Aeronautical Study No.
 2020-WTE-2279-OE
 Prior Study No.
 2020-WTE-2006-OE

**** DETERMINATION OF NO HAZARD TO AIR NAVIGATION ****

Structure: Met Tower (w/WT Farm) MET1
 Location: Clear Lake, SD
 Latitude: 44-36-35.89N NAD 83
 Longitude: 96-42-56.96W
 Heights: 1977 feet site elevation (SE)
 300 feet above ground level (AGL)
 2277 feet above mean sea level (AMSL)

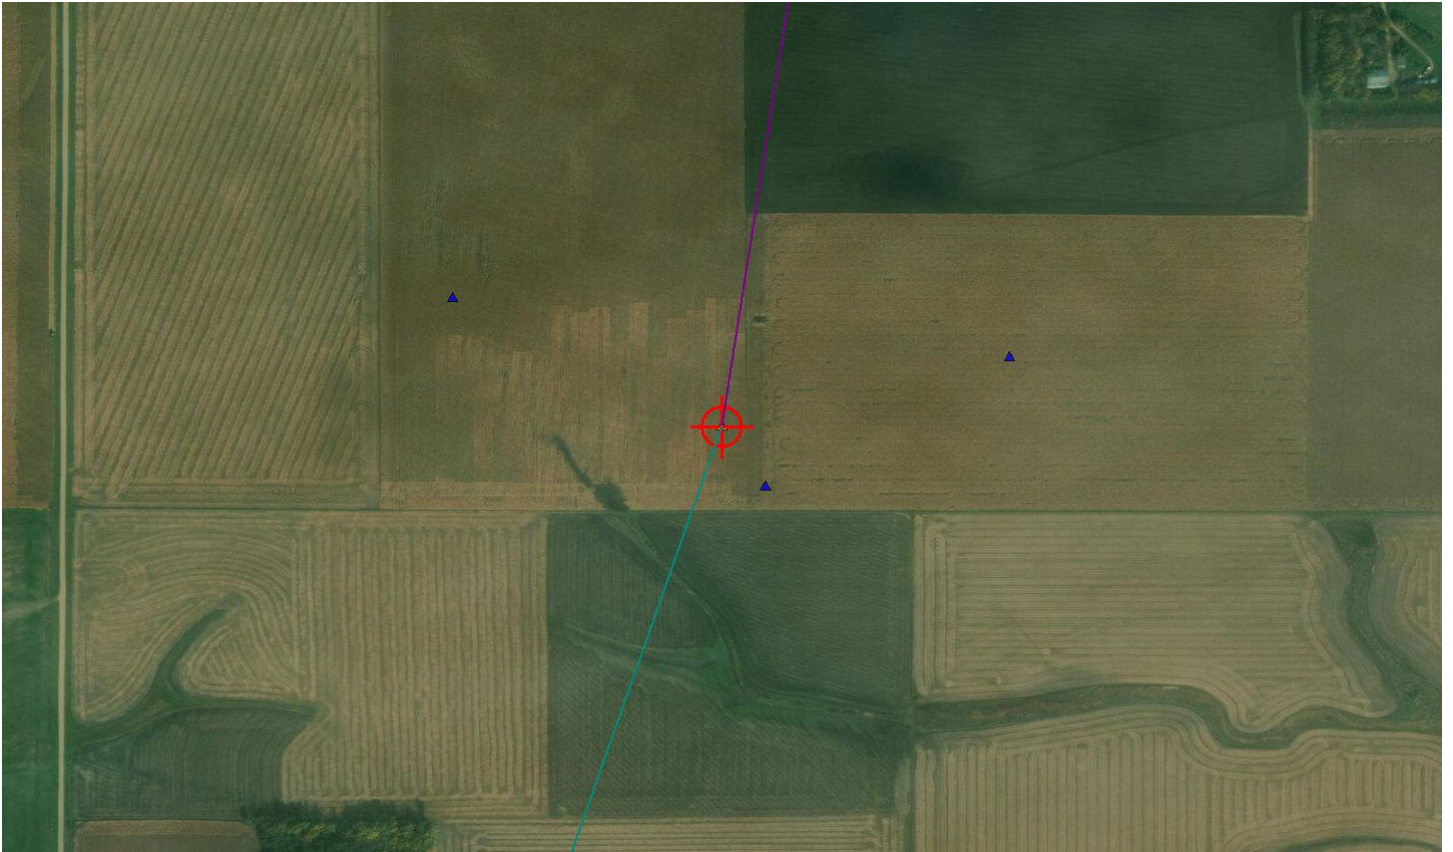
In addition to red obstruction lights, and as a condition of this determination, the structure must be marked in accordance with AC 70/7460-1L, CHG 2, Chapter 2.7:

It is recommended that several high-visibility sleeves be installed on the MET's outer guy wires. One high-visibility sleeve should be installed on each guy wire, as close to the anchor point as possible, but at a height well above the crop or vegetation canopy. A second sleeve should be installed on the same outer guy wires midway between the location of the lower sleeve and the upper attachment point of the guy wire to the MET. The use of sleeves should not impact the placement of spherical marker balls.

It is also recommended that high-visibility aviation orange spherical marker (or cable) balls be attached to the guy wires. The FAA recommends a total of 8 high visibility spherical marker (or cable balls) of aviation orange color attached to the guy wires; 4 marker balls should be attached to guy wires at the top of the tower no further than 15 feet from the top wire connection to the tower, and 4 marker balls at or below the mid point of the structure on the outer guy wires.
